## Notification

Subject : Connecting 9700V24 to Liftmaster GDO's

### 9700V24

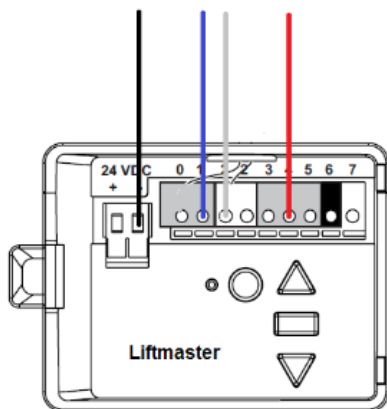
Because the output power supply of some Liftmaster operators is too high (36V instead of 24V) for the 9700V24. It is necessary to connect the 9700V24 as below.

The fault description when a 9700V24 is connected to the 24V out of a LM operators is a beep signal from the 9700V24 now and then or sometimes a spontaneously opening of the door. When the 9700V24 is connected as the drawing above this problem is solved.

Green	GND	push/exit button
Green	OPEN	
Blue	NO	dry output contact
White	COM	
Yellow	NC	
Black	GND	power supply
Red	+VCC

From now on there will be add an extra connecting instruction to the 9700V24. This instruction can also be find on our website.
